17TH + PETTYGROVE

Design Review Submittal 02 / February 20, 2017

LU 16-266376 DZM

FEEDBACK FROM DESIGN REVIEW COMMISSION ON HEARING #1 (02.02.2017)

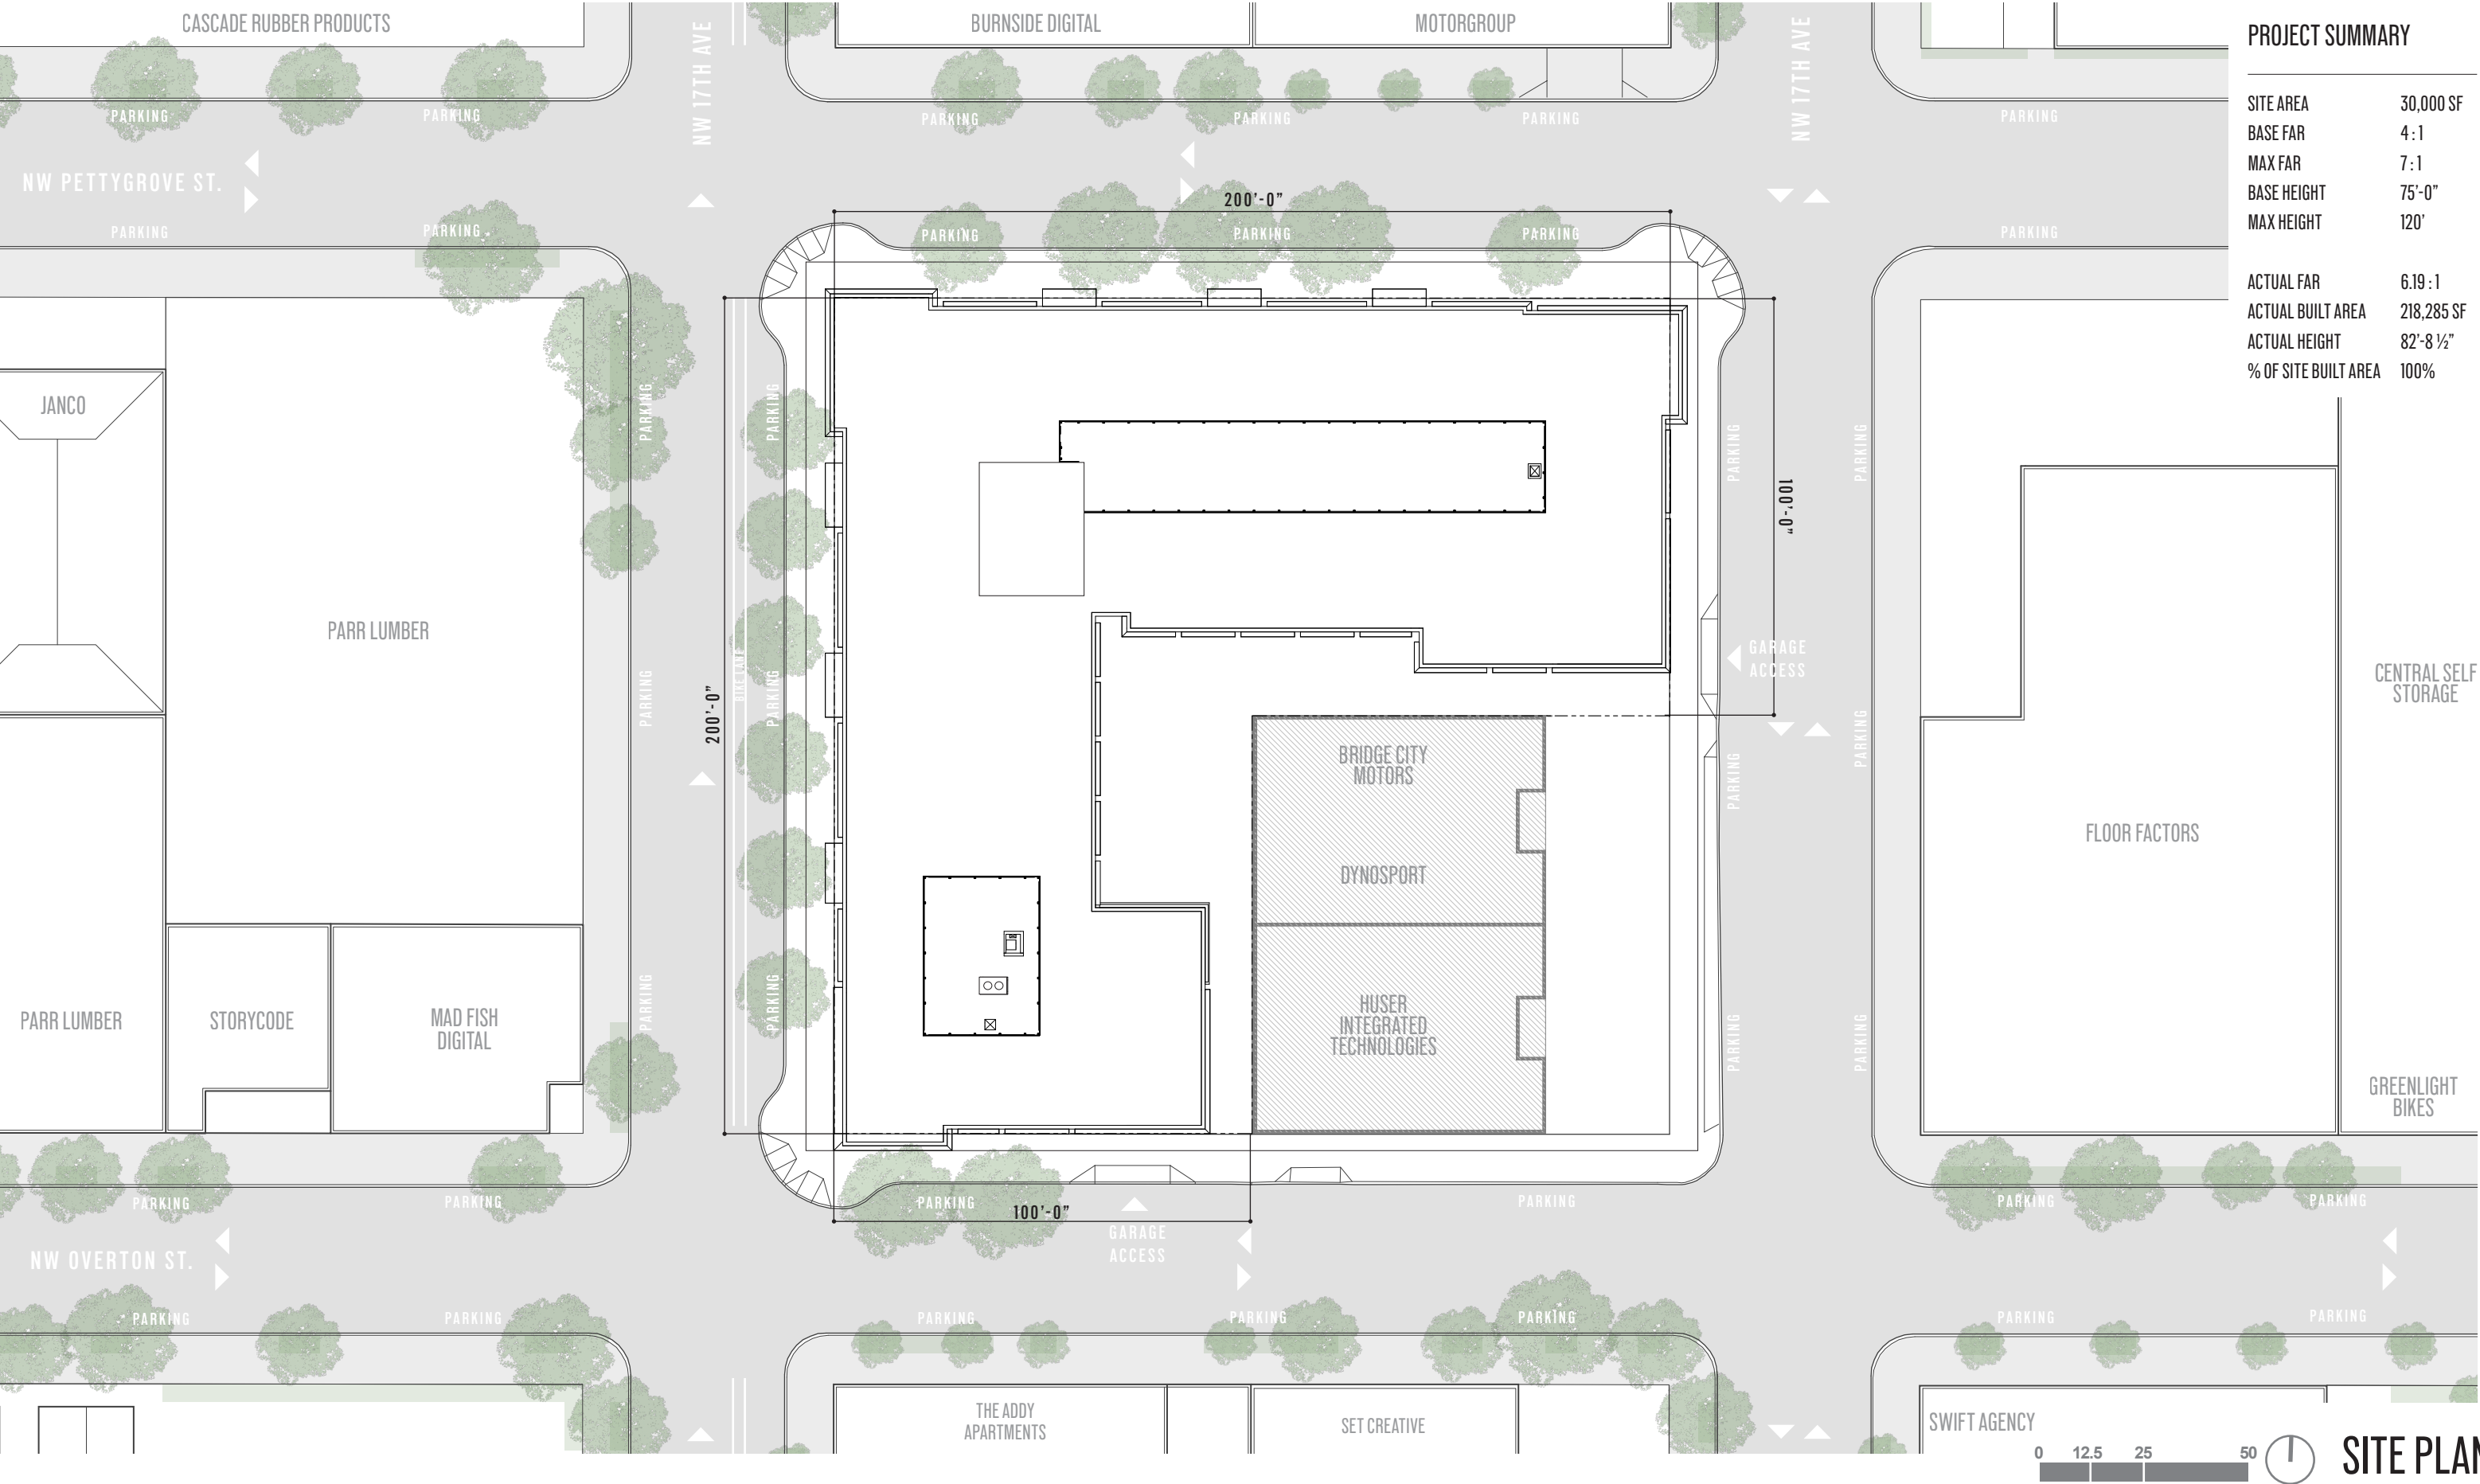
1. Overall Articulation & Patterning

- a. More transparent oriels within body of building
- b. Sameness to windows dilutes the special moments
- c. Building would benefit from maybe 1-3 projections that are unto themselves, rather than repeating the same projections

2. Materials

- a. Dark materials appear heavy
- b. Break up/separate projections from building to avoid monolithic massing
- c. Too much of the same cloth - repeated moves dilute the special qualities of the details

3. Second Floor Articulation

- a. Ambiguity in window pattern between second and upper floors
- b. Weak transition between second and upper floors
- c. Further differentiate 2nd floor as a transition between first and upper floors

Design Response: The proposed design update changes the language of the mid-block oriel windows to distinguish them from the cantilevered brick corners. These new projections aim for 'lightness' as a counterpoint to the visual weight of the brick. Additionally, the design update modifies the window patterning - by raising the sills of selected windows - in order to provide greater visual interest across the facades.

Design Response: In order to reduce the perceived 'masiveness' of the building, the proposed design update makes three changes to the material palette: a lighter brick, additional glazing / articulation at the new oriel windows and additional wood cladding at the ground floor storefronts. These revisions attempt to lessen the impact of the building mass while providing meaningful differences between one compositional element and another.

Design Response: The proposed design update attempts to further strengthen the reading of Level 2 as visually distinct levels 3 through 7 above. By providing an alternate window patterning and serving as visual and structural support for the oriels above, level 2 helps define the very real transition of concrete to wood frame construction in this '5 over 2' building.

OCCC/32/#1
Window Projections into Public Right-of-Way

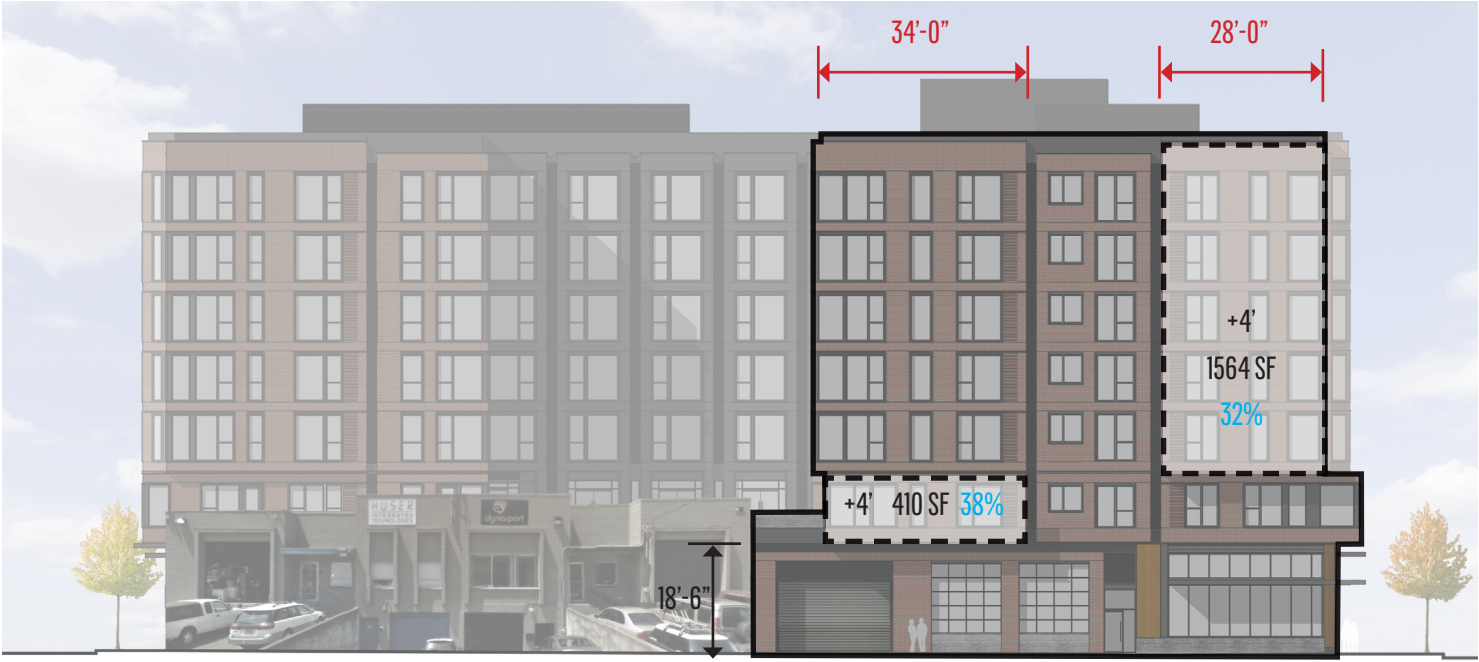
- E. - G.:** Approval being requested through Design Review as follows:

E. Project complies with all requirements of this standard.

F. Project requests approval through design review for widths of projecting window elements that exceed 12 feet but complies with standards C. and D. above. Please refer to the diagrams on the following pages where these conditions are shown with RED dimension strings.

G. Project requests approval through design review for one instance where the separation does not meet the minimum of 12 feet separation. This instance occurs on the West facade, as shown on the diagrams in the following pages (RED dimension string).
